## STAFF REPORT

**Case #18-18: SITE PLAN REVIEW**

Flaherty Drive  
ES John Vertente Blvd  
Map 133 Lot 61

**Applicant: Plumbers Supply Co.**

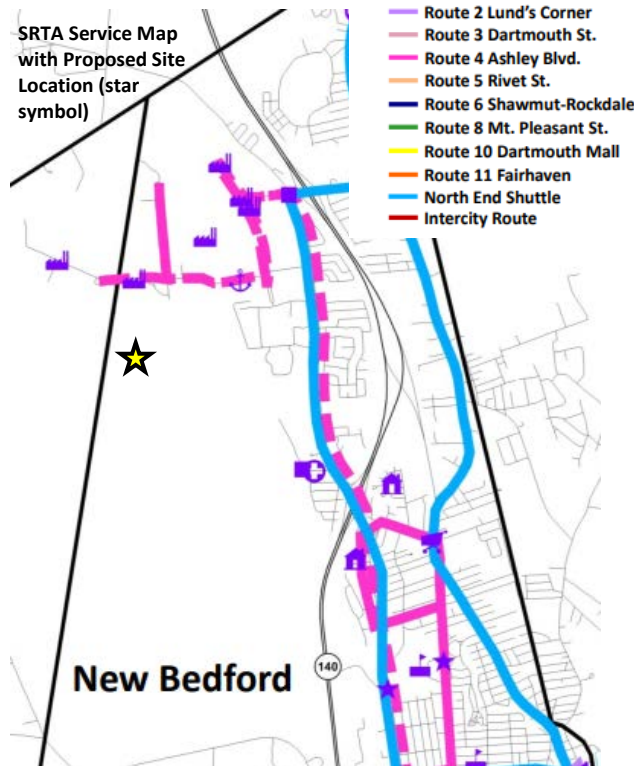
**Circulation.** Vehicles will access the site via a drive located off the end of Flaherty Drive. Internal drives will provide vehicular access around the building in a looped style. Employee parking would be located in the front (west) of the building. The plan includes curbed and landscaped areas in the front of the building to direct and control vehicular movements near the entrance, and employee parking area. Cape Cod Berm curbing is proposed for roadways throughout the site. Tractor-trailers will follow the northern drive to access the rear loading bays. A separate pull-through drive along the northern drive is proposed for the installation of a snow scraper. The proposed intent of the snow scraper is to remove snow from the truck trailer roofs. There is a sidewalk transition proposed to the east of the set of 50 proposed parking spaces at the west (front) entrance of the proposed site.
